UNITED STATES PATENT AND TRADEMARK OFFICE

Office Action Summary	Application No. 10/697,148	Applicant(s) GRUNWALD ET AL.	
	Examiner Ali Imam	Art Unit 3737

DETAILED ACTION

Fig. 1

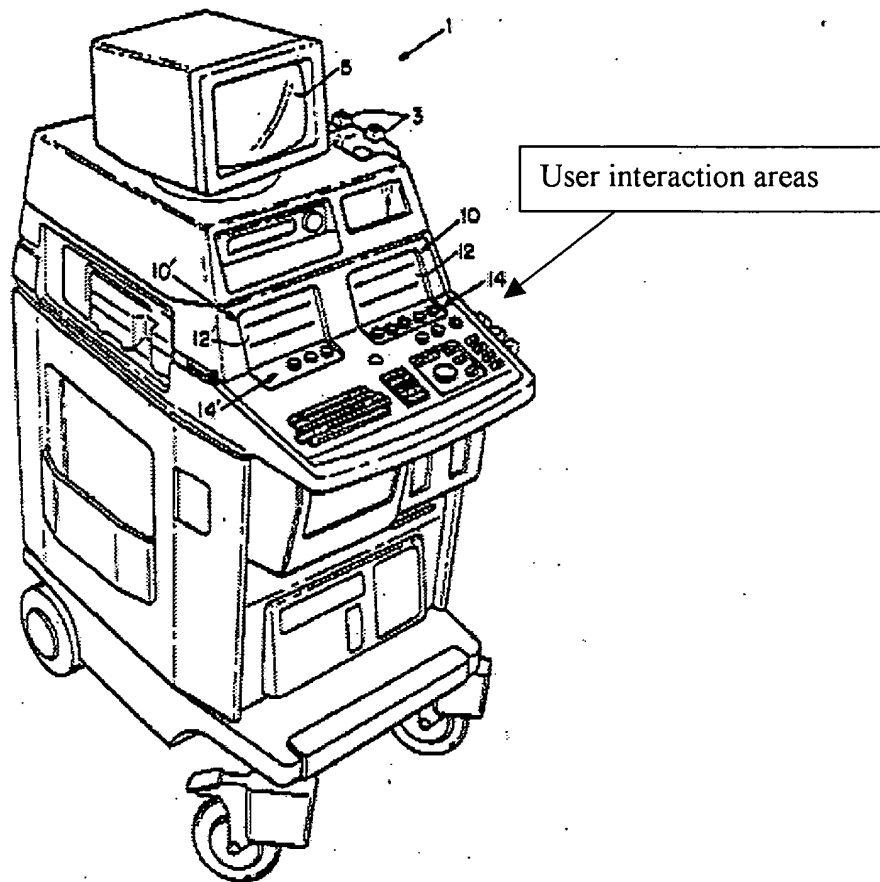
In regard to claims 1, 21, 42, 47, and 53, Short teaches in Figs. 1-9 a user interface for an ultrasonic imaging system (1) wherein the user interface comprising a set of display (12, 12') and user interaction areas (see Fig. 1 below) including an image display area (5) to display ultrasonic images; a control area (10, 10') including elements (see Fig. 2 below) configured to enable a user to access a plurality of operation modes, said elements having active behavior that provides timely user control of the ultrasonic imaging system whereby each of the display areas can interact with the user independently in order to provide timely response to specific user requests. Furthermore, Short teaches rotatable control buttons (25, 28, 36, 38, and 40) which obviously maintain a history of user interaction. Short further teaches that the two displays can be eliminated by providing one large display that is large enough to display both the imaging and non-imaging (patient information) information (col. 8, lines 30-37).

In regard to the dependent claims 4-7, 9, 10, 12, 15, 18, 19, 24-28, 30, 31, 33, 36, 39, 40, 45-47, 50-52, Short teaches various touch screen, tabs, or programmable function keys (see Fig. 2 below) in the control area. Furthermore, Short teaches that the ultrasonic imaging system is portable (see the wheels on Fig. 1).
